RESOLUTION NO. 557

A RESOLUTION OF THE CITY COUNCIL OF THE CITY OF REDMOND, WASHINGTON, APPROVING THE PRELIMINARY PLAT OF WETHERSFIELD (PP-79-6) AND APPROVING THE HEARING EXAMINER'S RECOMMENDATIONS.

FINDINGS AND RECOMMENDATIONS  
OF THE HEARING EXAMINER OF THE  
CITY OF REDMOND

File No. PP-79-6

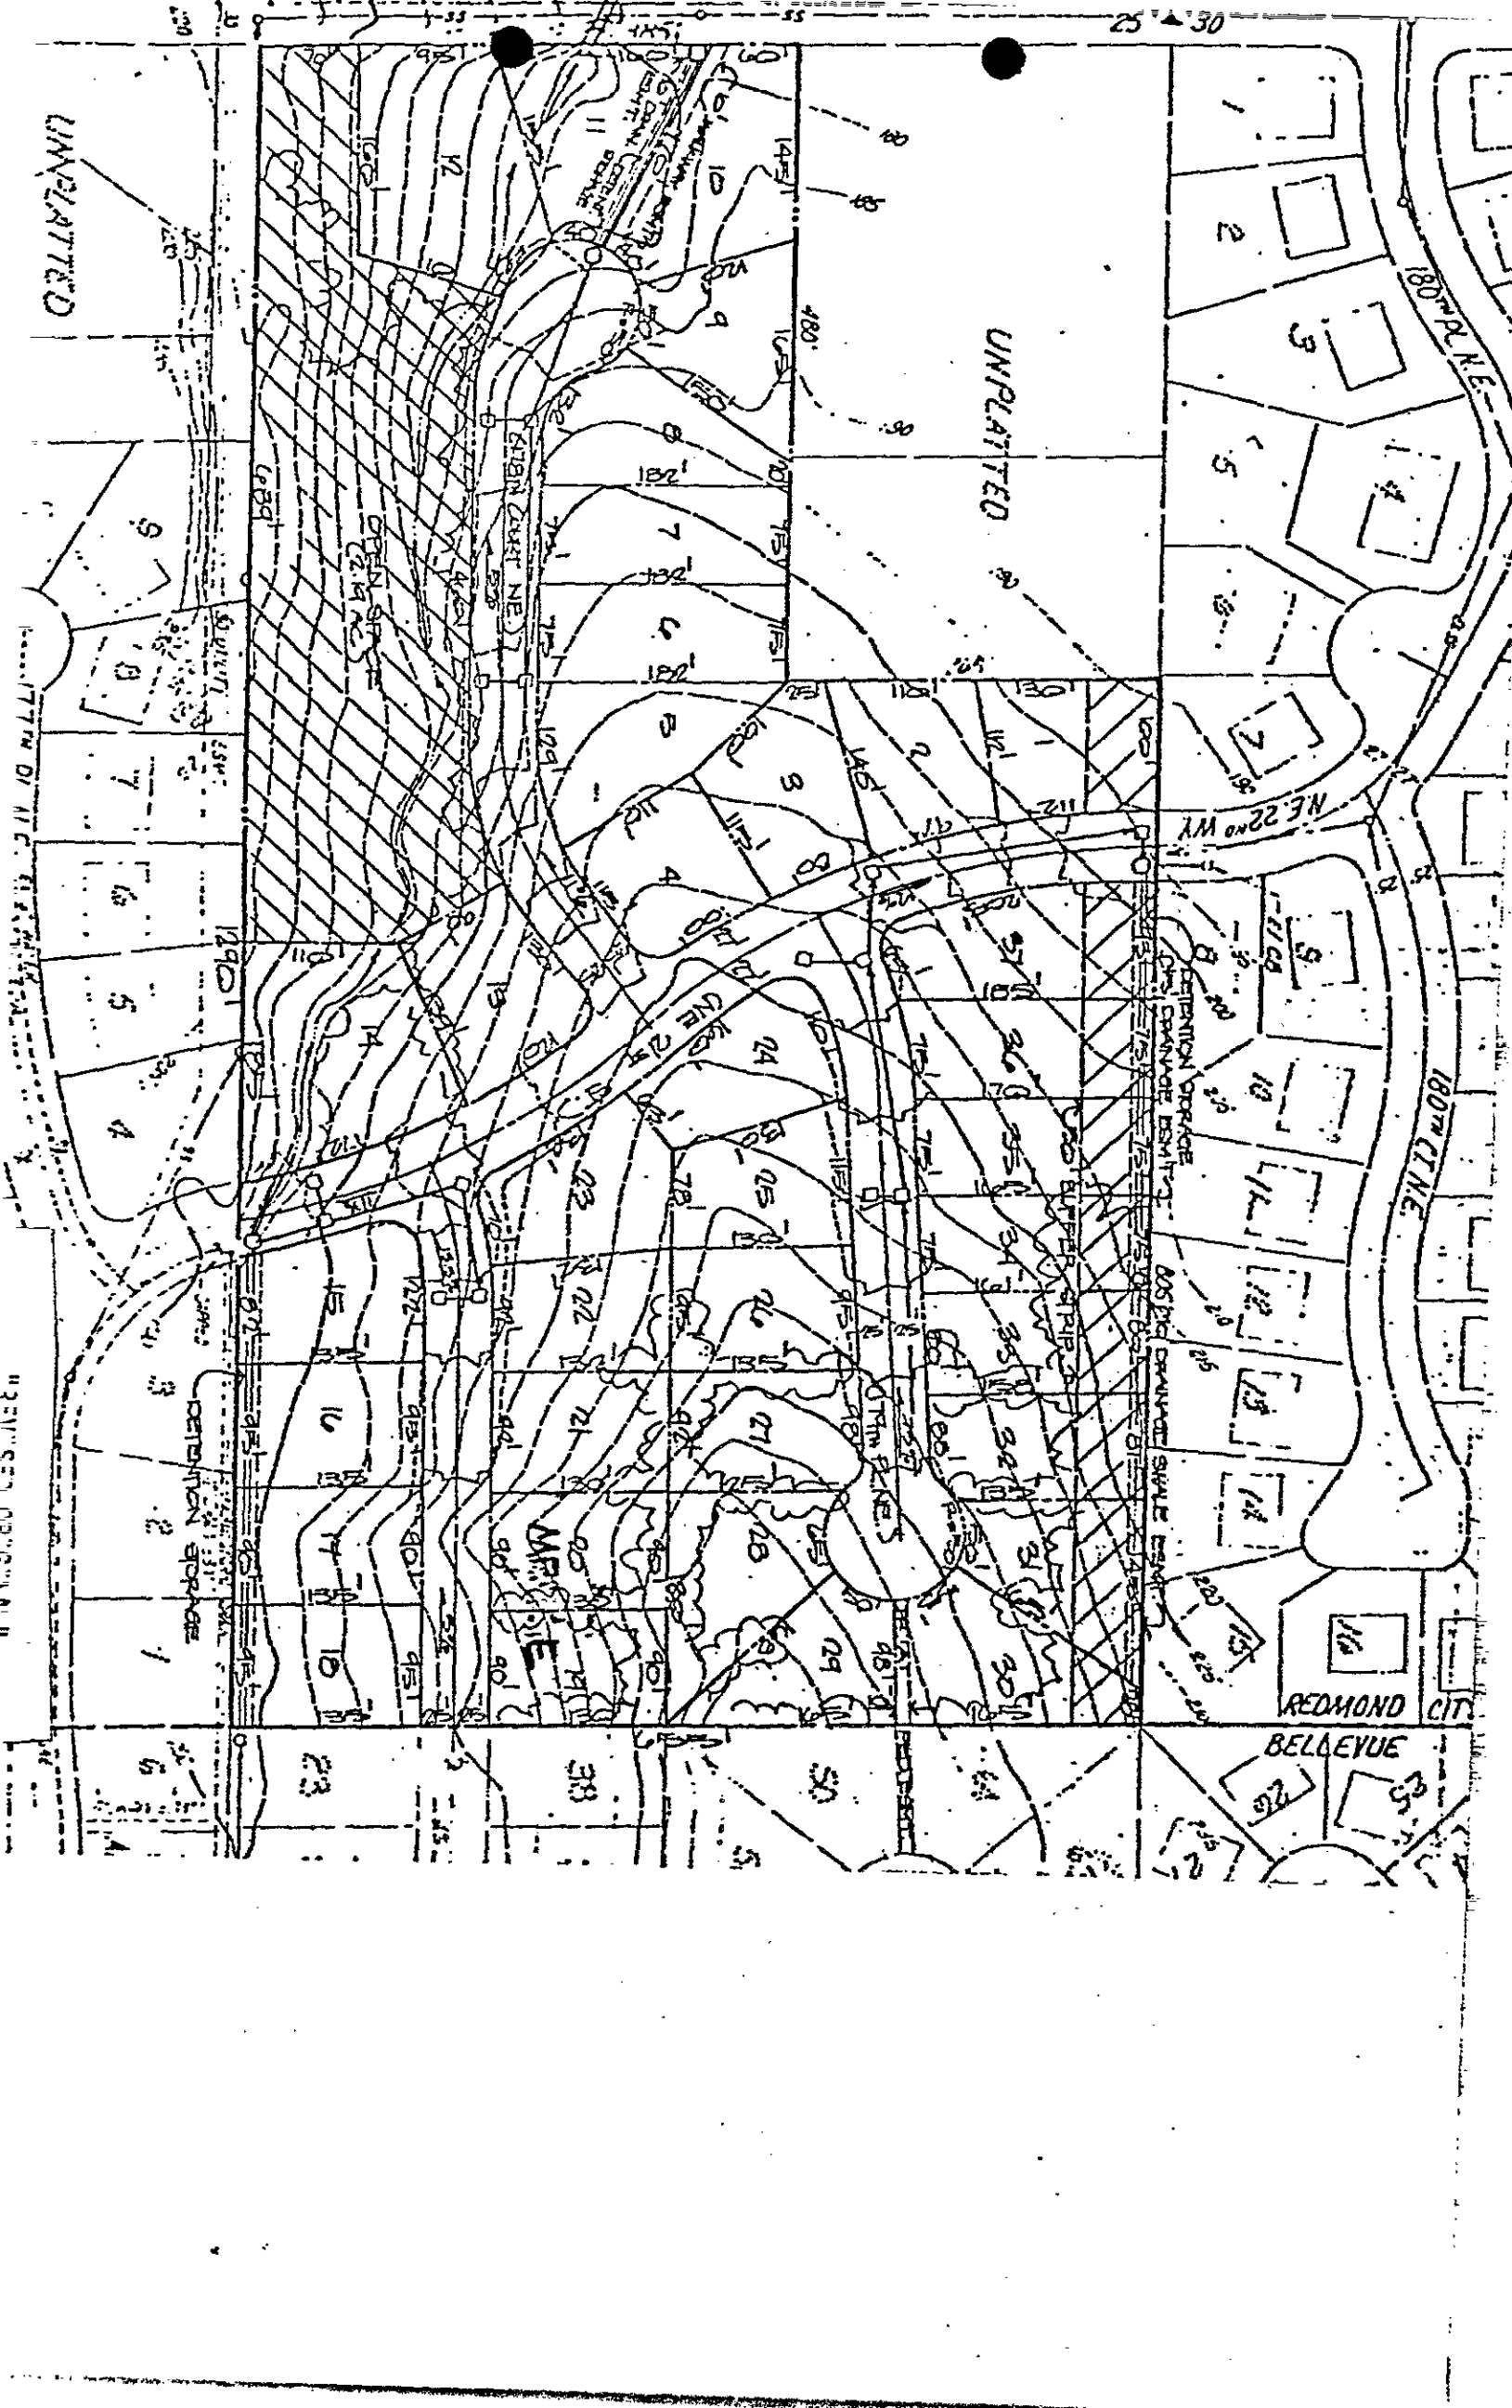
13. In the site plan identified as "Revised Original" the traffic circulation is as follows: there is no access to the subdivision from the north and the south. Access to the subdivision from the east is via an extension of N.E. 22nd Way which transects the subdivision to the west access off 177th Avenue N.E. in the Argyle Addition of Bellevue. There are three cul-de-sacs in the subdivision; namely, the cul-de-sac for 179th Place N.E. which runs to the north of the extension of N.E. 22nd, a cul-de-sac of 178th Avenue N.E. which runs to the north of N.E. 22nd, and a cul-de-sac at 178th Court N.E. which runs to the northerly section of this subdivision.

14. During the course of the hearing, much testimony was received from the residents of Cedar Lane Estates objecting to the circulation of traffic as proposed in the site plan identified as "Revised Original." The main objection to the traffic circulation of this plan was that increased traffic would result on 180th Place N.E. of the Cedar Lane Estates, thereby causing increased traffic flow and increased danger to the residents of that area.

15. Objection to the traffic circulation, of the site plan identified as the "Revised Original," was received from the Redmond Police and Fire Departments. Basis of the objection was that the proposed traffic circulation created difficulties for emergency vehicles who need access to the area.

16. Testimony was presented by the owner of a parcel of land, located adjacent to the northeast corner of the Wethersfield addition, in support of the traffic circulation as proposed in the site plan identified as "Revised Original." The testimony presented was that, for safety reasons, the access to the Wethersfield addition could only occur off N.E. 24th Street onto 180th Avenue N.E. as set forth in the "Revised Original" site plan. Any other access to the Wethersfield property off N.E. 24th Street would create severe safety problems because of the severity of the grade on N.E. 24th Street.

**ALTERNATE "A"**

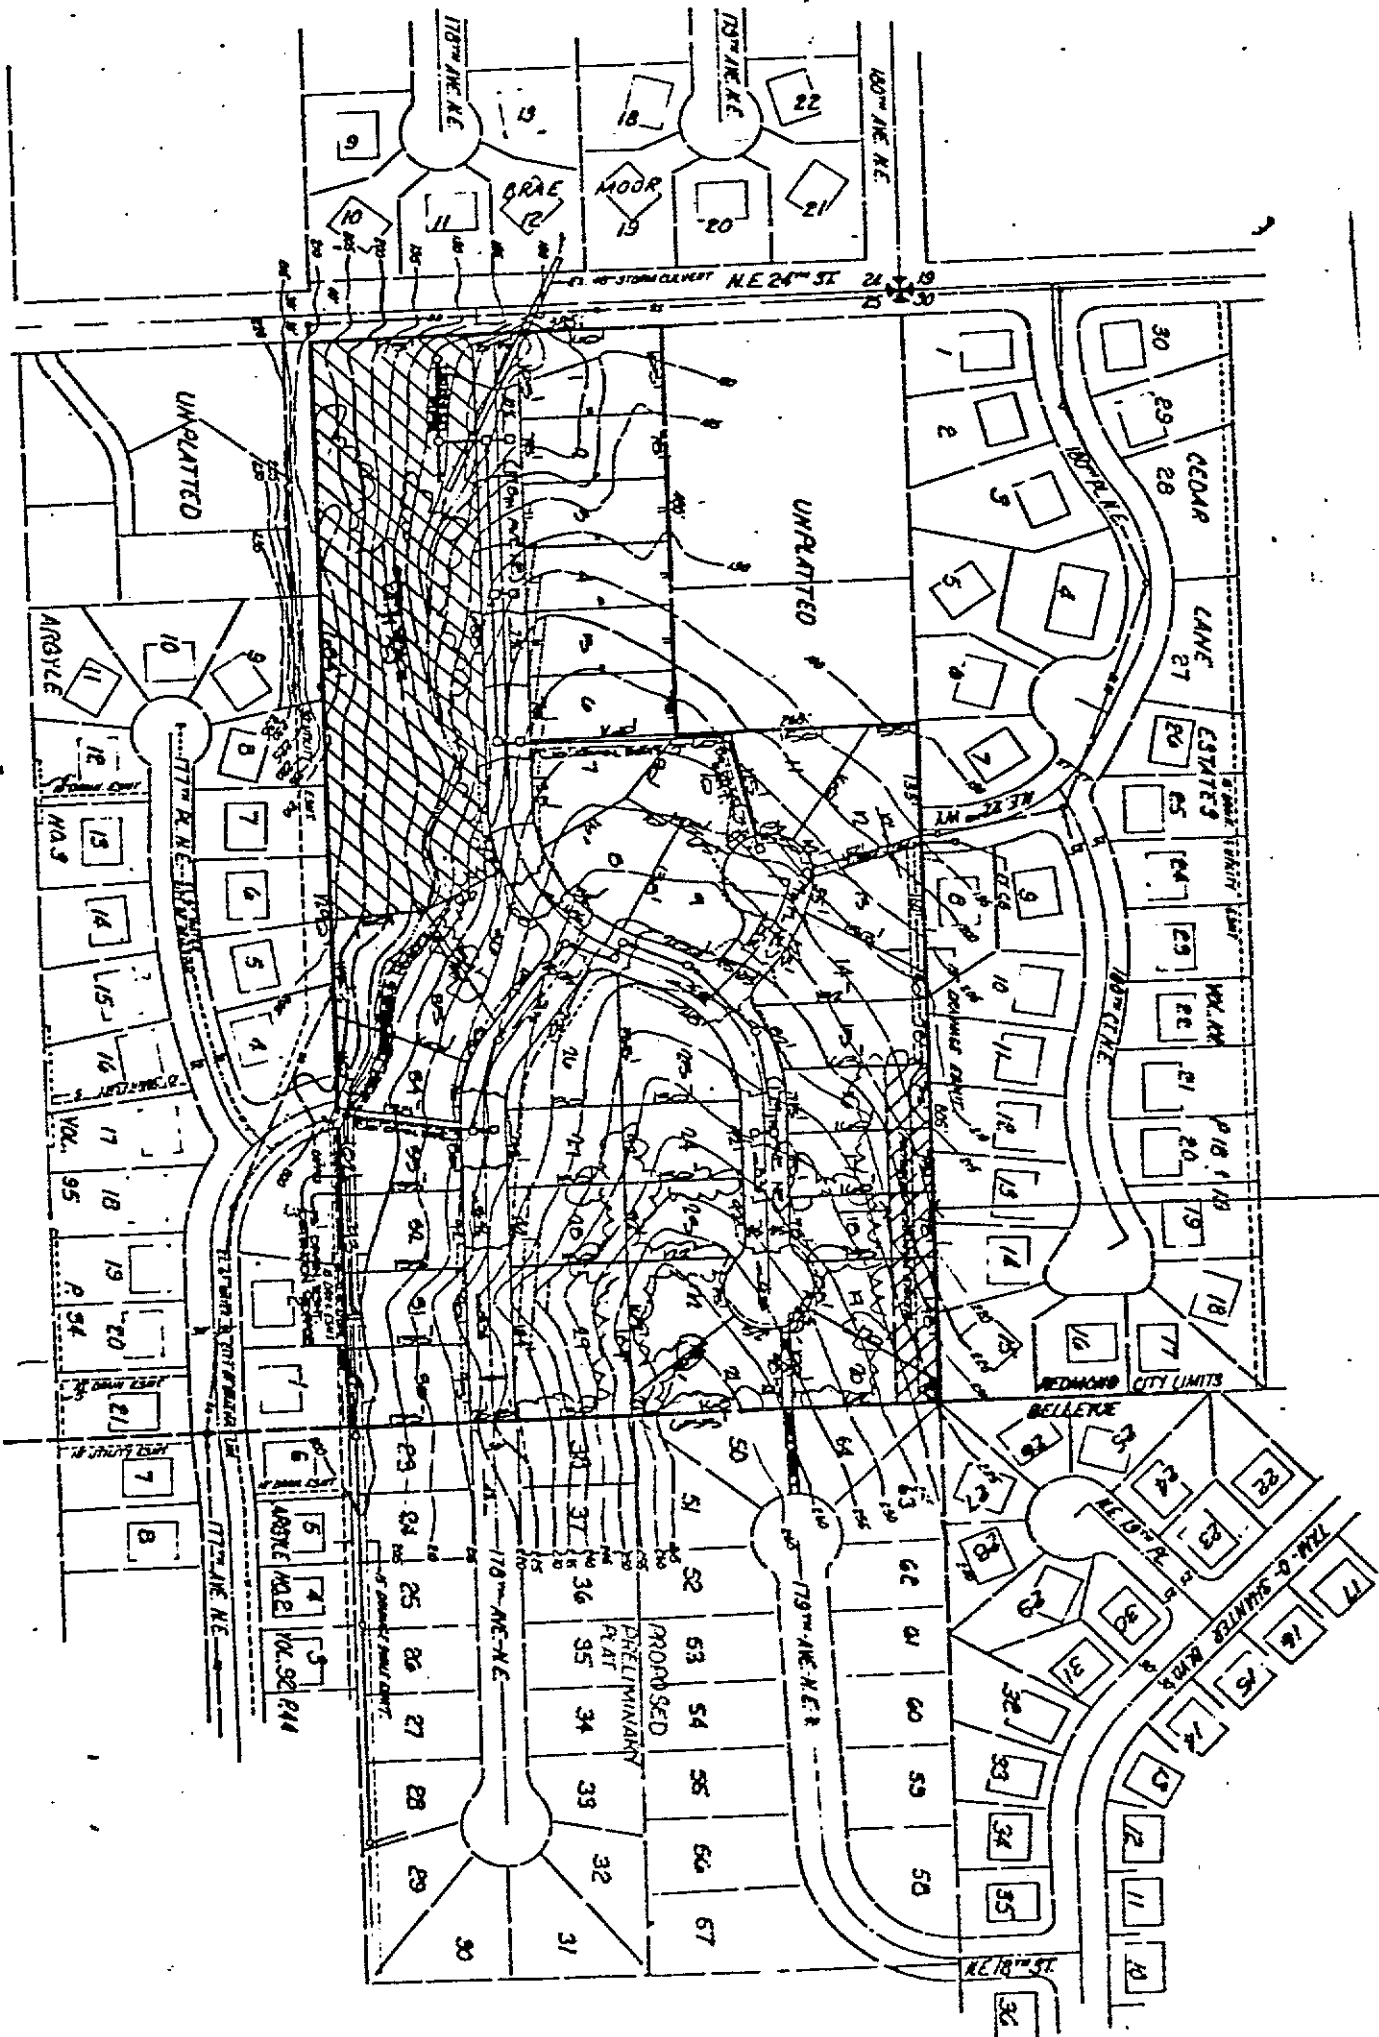
17. In the site plan, identified as "Alternate A," the traffic circulation is as follows: there is no access to the Wethersfield subdivision from the east or from the south. Access to the subdivision is from the north off N.E. 24th Street onto 178th Avenue N.E. which transects the subdivision and ends in a cul-de-sac in an area south of the proposed subdivision. At approximately the middle of the subdivision, 178th Avenue N.E. intersects with 179th Avenue N.E. 179th Avenue N.E. forms a cul-de-sac at the south-easterly edge of the subdivision. Another cul-de-sac occurs at 179th Place N.E. which is off 179th Avenue N.E. in the central part of the subdivision. There is no access to the subdivision contained in "Alternate A" site plan off N.E. 22nd Way or off 177th Avenue N.E.

18. Testimony was received in support of the traffic circulation as set forth in site plan "Alternate A." The testimony was given by the Cedar Lane Estates Homeowner's Association.

19. Testimony was received at the hearing in opposition to the traffic circulation as proposed in site plan "Alternate A." The basis of the objection for the traffic circulation in this site plan was the difficulty in making a right-hand turn off N.E. 24th Street onto 178th Avenue N.E. The difficulty results because of the steepness of the grade of N.E. 24th Street at the point of the intersection.

20. Evidence was presented that the Redmond Police and Fire Departments opposed the traffic circulation in "Alternate A." The main problem with "Alternate A" would be the access of emergency vehicles to the area.
